HISTORIC AND DESIGN REVIEW COMMISSION

Agenda Item No: 18

HDRC CASE NO: 2015-451
ADDRESS: 528 RIVERWALK
LEGAL DESCRIPTION: NCB 148 BLK LOT W 10.7 FT OF 5, S 119.66 FT OF 6 & 6.5
ZONING: D H HE RIO-3
CITY COUNCIL DIST.: 1
DISTRICT: Alamo Plaza Historic District
LANDMARK: Bennett / River Square Bldg / Atwell Addition
APPLICANT: Jose Sanchez/The Original Mexican Restaurant
OWNER: The Original Mexican Restaurant
TYPE OF WORK: Menu board attached to hostess station
REQUEST:

The applicant is requesting a Certificate of Appropriateness for approval to install a menu board at the Riverwalk level.

Rear Dimensions Same as
Front

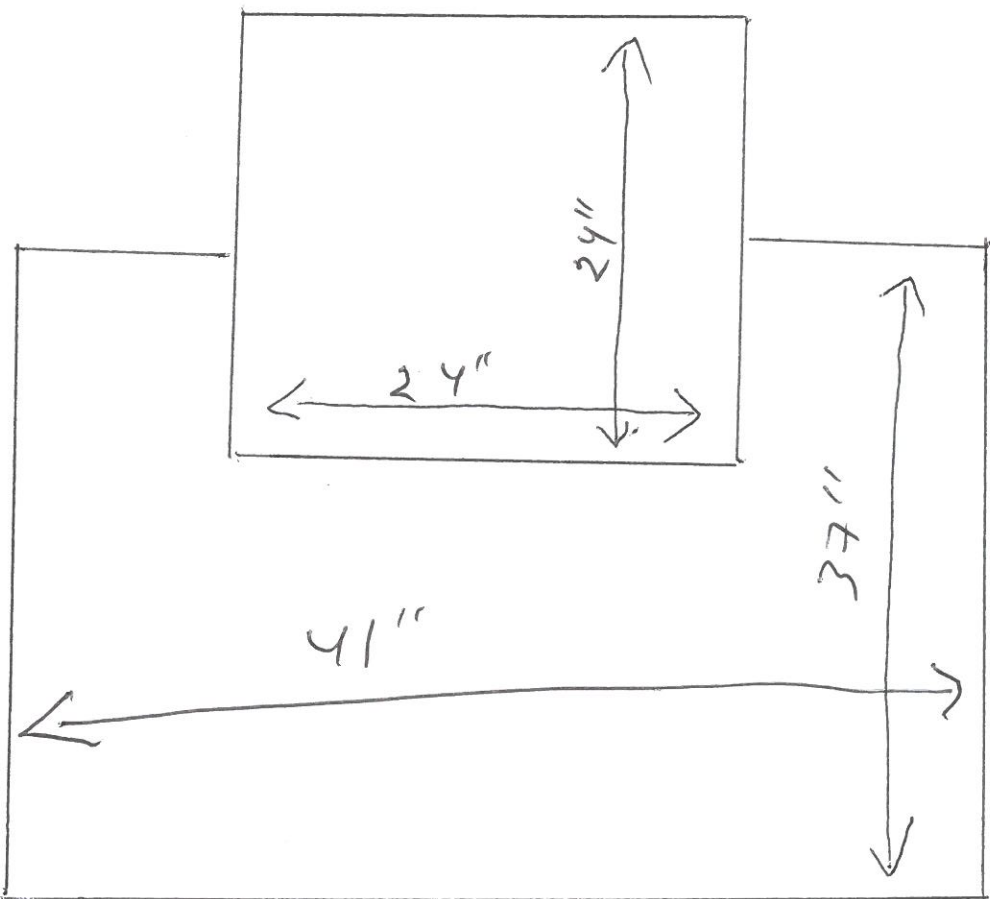
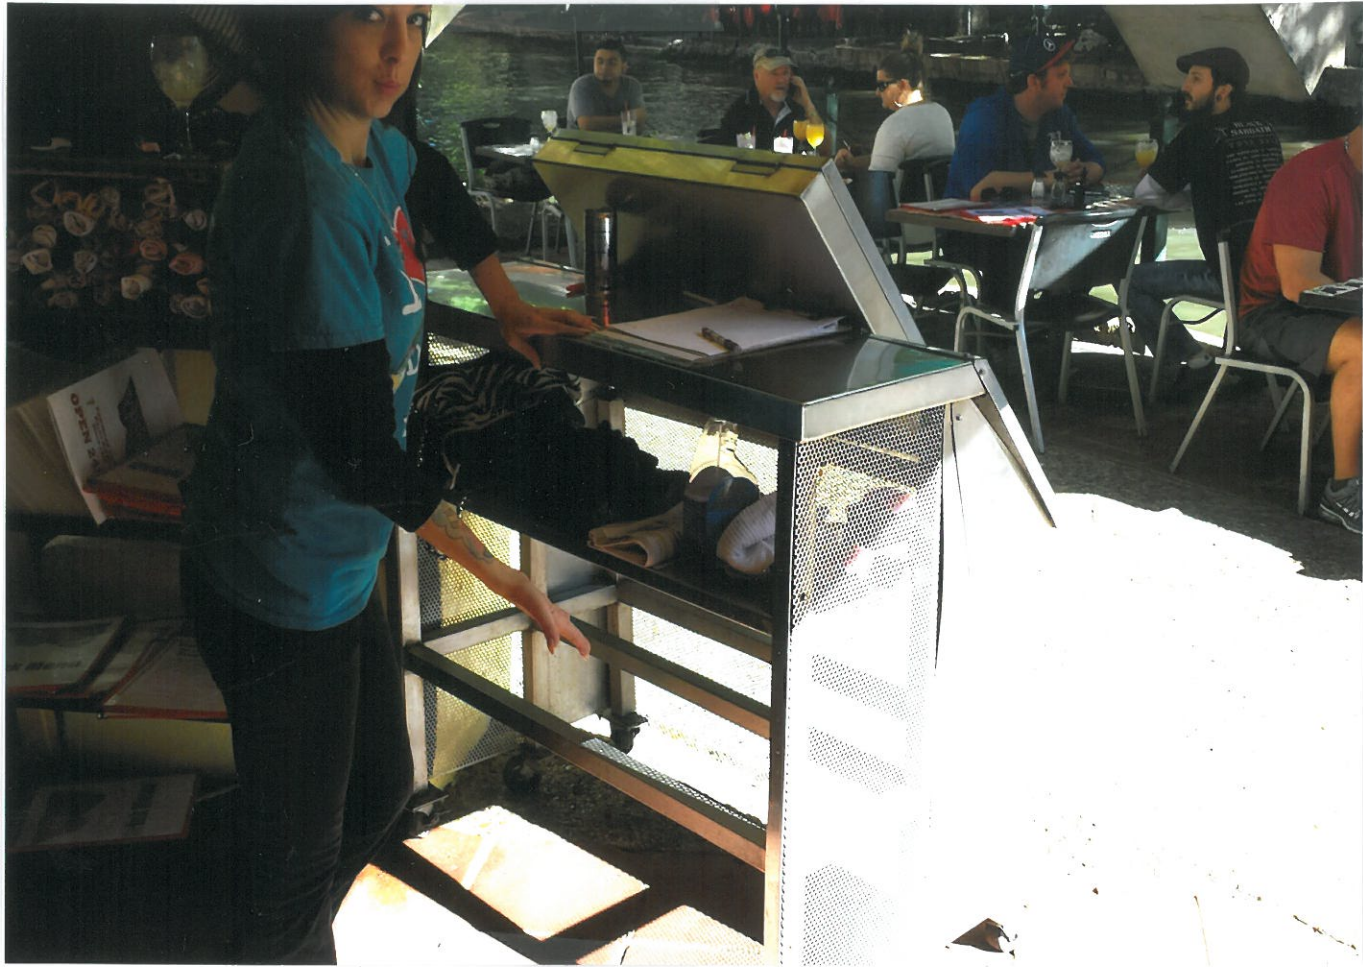
- a. The applicant has proposed to mount a menu board to a non permanent hostess station at the Original Mexican Restaurant located at 528 Riverwalk. The applicant has proposed the menu board's display area to be two feet in width by two feet in height. The UDC allows for menu boards to be no larger than two (2) square feet. This applicant's proposal is not consistent with the Guidelines.
- b. Per the UDC Section 35-678)(g)(2), permanently displayed menus may be properly installed inside the business' window or in an approved wall-mounted or freestanding display case adjacent to the business entrance. The applicant has proposed to mount the proposed menu board to a hostess station, which includes dimensions greater than allowed by the UDC. This is not consistent with the Guidelines.

Staff does not recommend approval. Staff recommends that the applicant propose a menu board that is permanently located near the restaurant's entrance that does not exceed two (2) square feet.
